July 24, 2013

RE: TRUMBULLCOUNTY
CITY OF GIRARD
TRINITY HIGHWAY PRODUCTS LLC
NPDES PERMIT NO. OHR000005
OHIO EPA PERMIT NO. 3GR01279*EG
INDUSTRIAL STORM WATER INSPECTION

Figure 5 - A tow lift was observed leaking fluids outdoors.

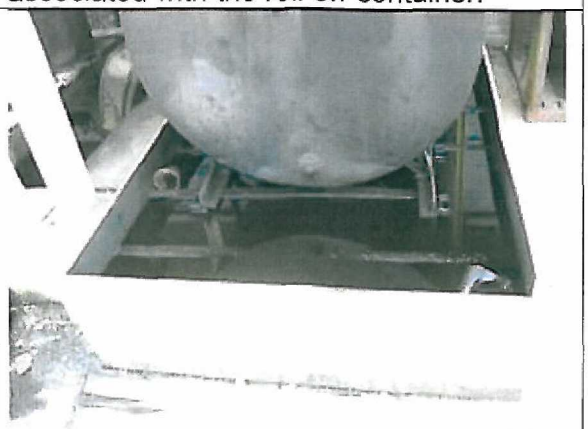
- A tow lift awaiting maintenance is being stored outdoors in an area exposed to precipitation events and was observed leaking fluids (Figure 5). Appropriate BMPs (i.e. relocating leaking equipment under roof, using drip pans, etc.) must be implemented to prevent the discharge of pollutants.

Figure 9 - A drill that is expected to be shipped from the facility is leaking oil.

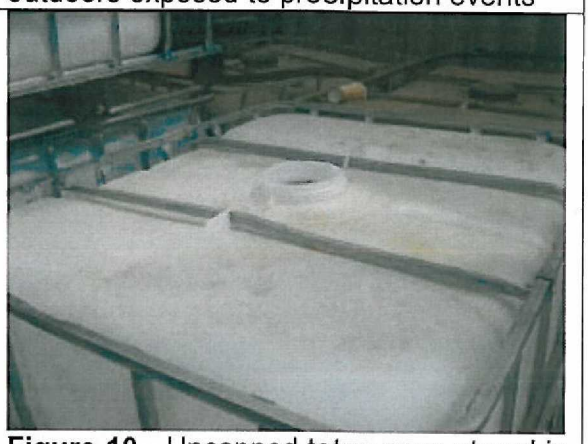
- A drill that is expected to be shipped from the facility is leaking oil (Figure 9). Appropriate BMPs (i.e. tarping and drip pans, proper draining, etc.) must be implemented to prevent the discharge of pollutants.

Figure 11 - Tow lift radiators are washed in a location that drains outdoors.

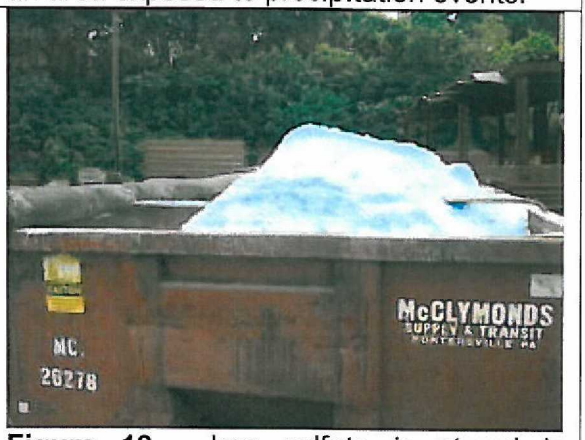
- Tow lift radiators are washed in a location that drains outdoors (Figure 11). Please be aware that this is a wastewater that is not authorized for discharge under the Multi-Sector General Permit. This wastewater must be properly managed via one of the following options:

- Obtaining an NPDES permit to authorize the discharge;
    - Directing the wastewater into a sanitary sewer for proper treatment; or
    - Obtaining a permit-to-install for the installation of holding tank designed to collect and hold the wastewater. The wastewater is then properly treated and disposed offsite.
